**LIDL GREAT BRITAIN LTD**

**LEADON WAY, LEDBURY**

**Response to HC comments in relation to  
transport matters**

23-00942/TN/01

**Figure 2.1: HC Public Rights of Way map extract for site area**

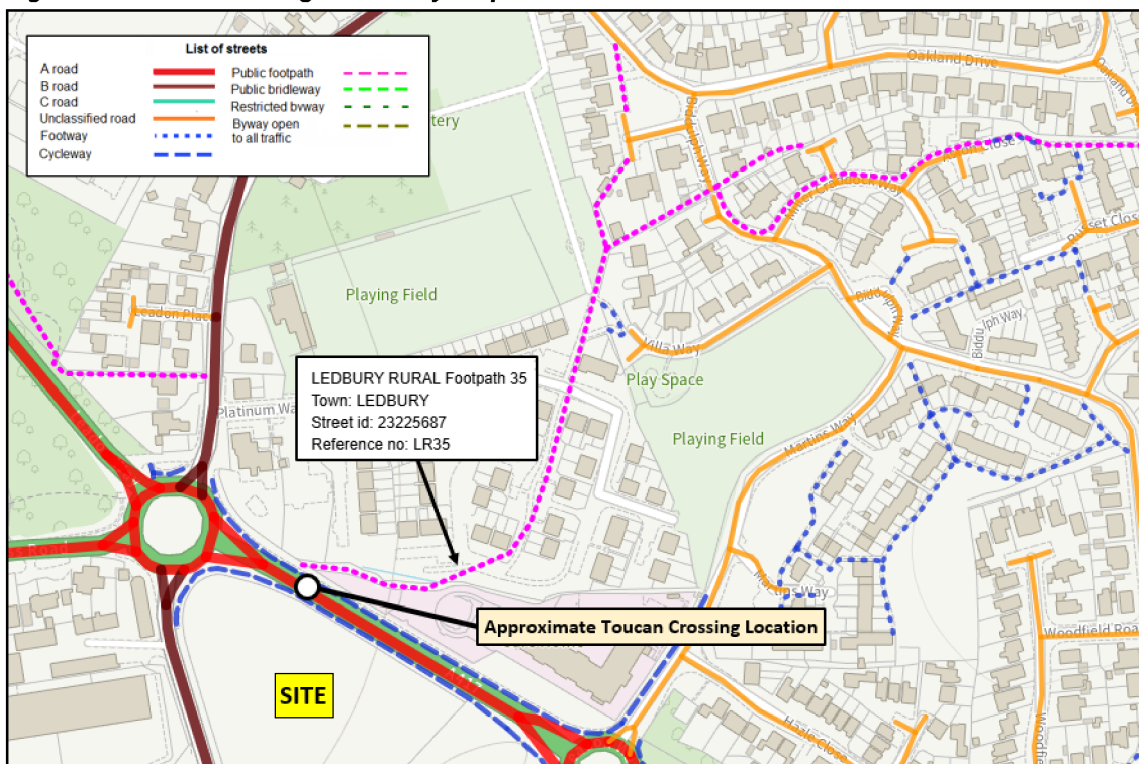
*Additionally, the proposed Toucan crossing should be relocated further east to align with the existing and improved Public Right of Way (PROW), enhancing connectivity and providing a more direct route into the site.*

As identified in the drawings contained at **Appendix B** of this TN, the proposed new Toucan crossing has been re-located to a position 60m east from the Full Pitcher roundabout (CD 116 requires it to be a minimum of 60m from the roundabout give-way).

As shown in **Figure 2.1**, this revised Toucan crossing position is in alignment with the PROW route to the north of Leadon Way, which in turn provides an onward pedestrian route into and through the residential area of Ledbury directly to the north of the site.

**Figure 2.2: Existing pedestrian connections provided at Full Pitcher roundabout between Dymock Road and Ross Road**

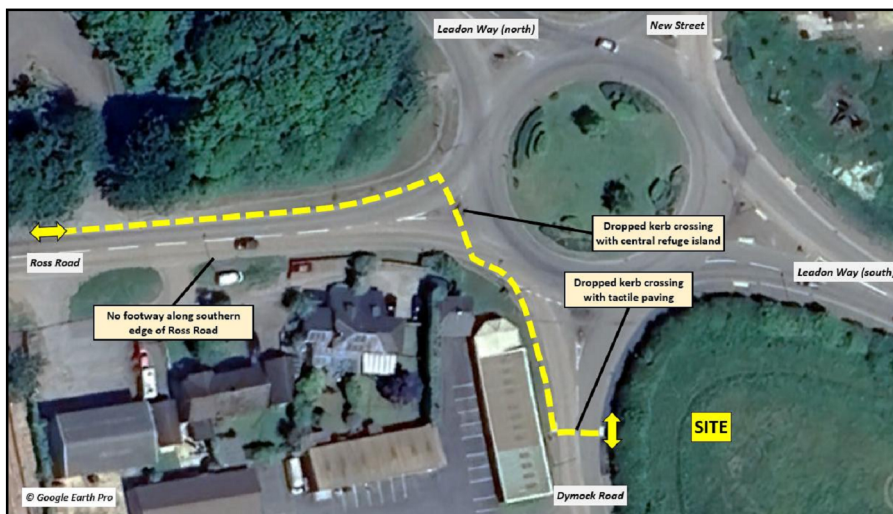
*Connections should be provided around the western side of the Full Pitcher roundabout to connect Dymock Road to Ross Road.*

Existing pedestrian connections at the roundabout between Dymock Road and Ross Road are identified on **Figure 2.2**. This identifies that Ross Road includes a narrow footway along the northern side of the carriageway, with no footway along the southern edge of the carriageway. A dropped kerb arrangement (including central refuge island) connects to a footway along the western edge of the B4216 Dymock Road arm of the junction. Onward movements into the site are then accommodated via a further dropped kerb crossing connecting between footways along either side of the Dymock Road carriageway.

**Extract 2.2: Footway widths (DfT 'Inclusive Mobility' 2002)**

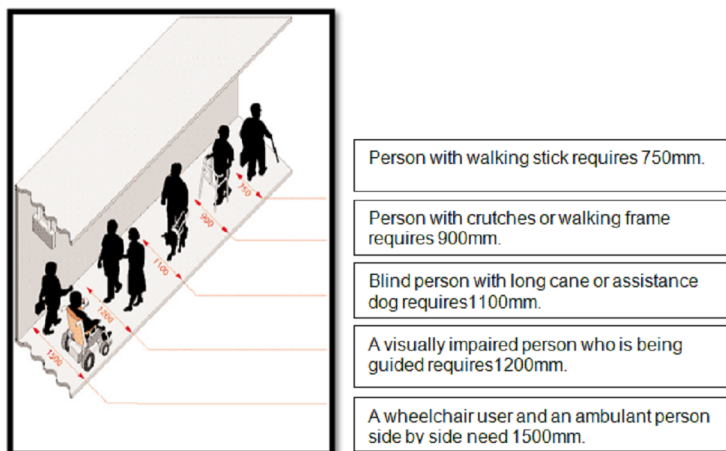
*It is noted that LTN 1/20 has not been used as part of the assessment submitted in the Transport Assessment. Details should be provided on how the proposals align with LTN 1/20*

LTN 1/20 identifies that the terms pedestrian and walking include people using mobility aids such as wheelchairs and mobility scooters designed for use on the footway, and people with physical, sensory or cognitive impairments who are travelling on foot. As also shown in **Extract 2.2** below from DfT's 'Inclusive Mobility' document (2002), a minimum of 1.5m is required to comfortably accommodate a range of users from a person with a walking stick, up to a wheelchair user and an ambulant person side by side.

Further to this, paragraph 5.2.3 of LTN 1/20 identifies that '*Cyclists travelling side by side (on a level surface) require a minimum space of 1.0m each plus 0.5m separation between them*'. This therefore equates to a minimum width of 2.5m. Table 5-2 of LTN 1/20 also states that for a 2-way cycle route (including light segregation) on a route with less than 300 cycles per hour (as anticipated at the site), a desirable minimum width of 3.0m is required, with an absolute minimum width of 2.0m.

The proposed internal pedestrian and cycle access link widths of 3m are therefore more than suitable for a variety of users, and conform with LTN 1/20 requirements.

Intervisibility between incoming  
HGV and outgoing large car

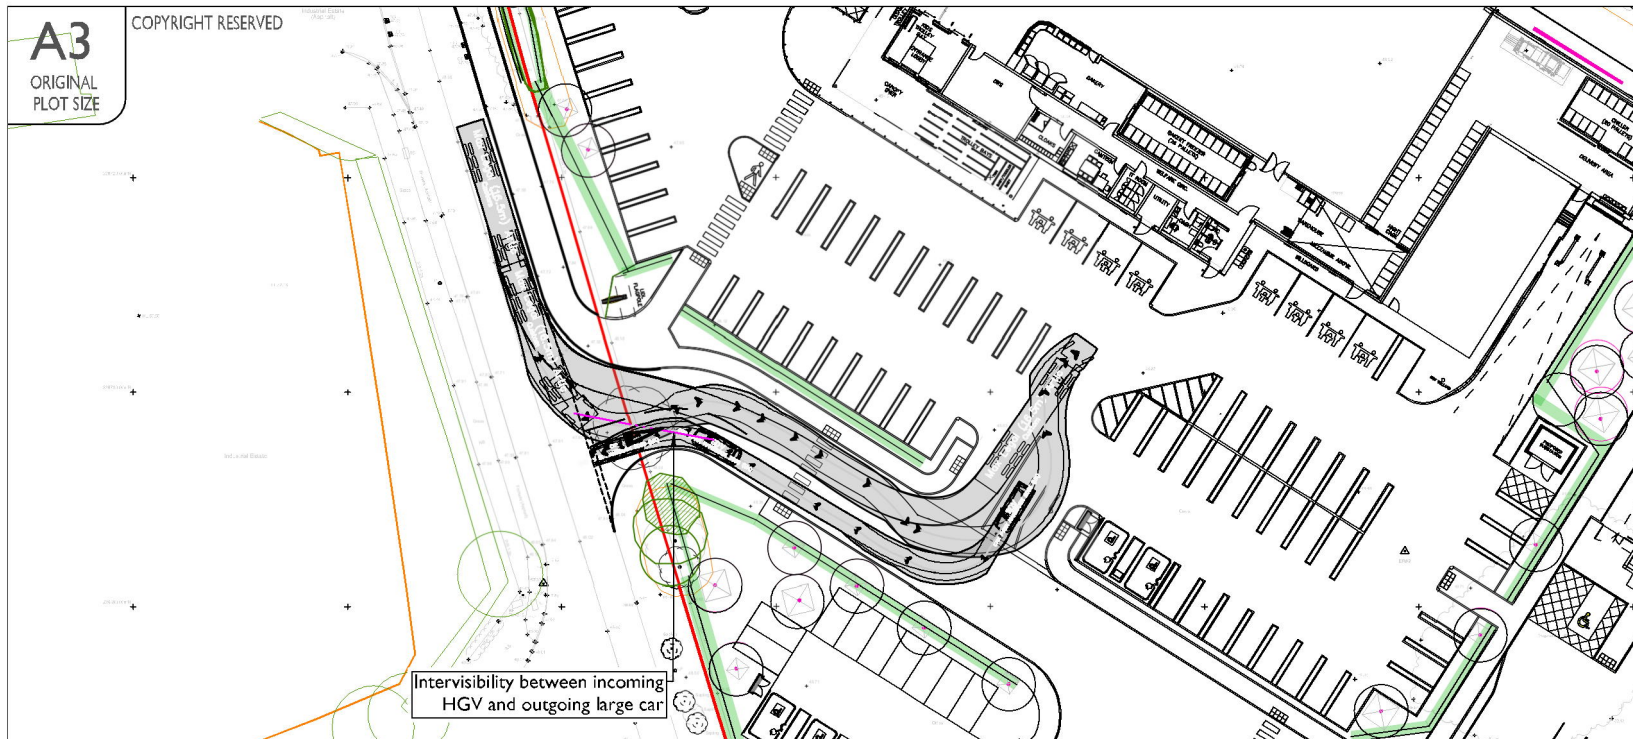
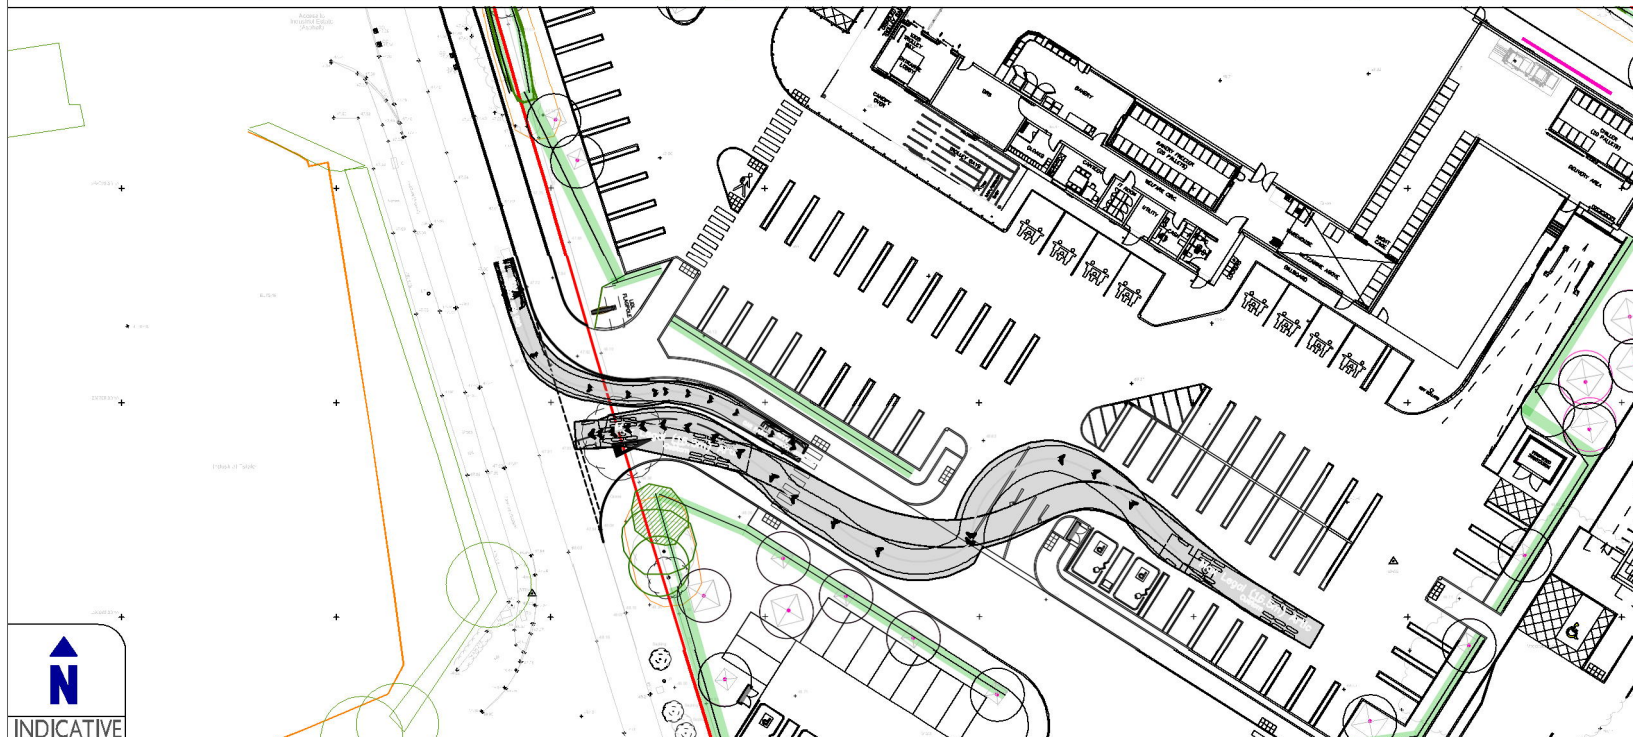
*The proposed access arrangement requires modification. As shown in the submitted plans, the HGV manoeuvre does not maintain a consistent alignment when negotiating the junction and internal carriageway. To address this, potential adjustments may include relocating the junction further northwest, closer to the Lidl sign, or widening the junction to better accommodate HGV turning movements. Tracking needs to be provided for the altered access.*

The proposed development would be anticipated to generate only a very small volume of HGV trips into the site, with no more than a couple of HGV trips anticipated over any individual day.

As identified in the tracking drawings contained at **Appendix B** of this TN, the updated layout provides sufficient capacity and visibility to accommodate HGV movements through the proposed site access and internal layout.
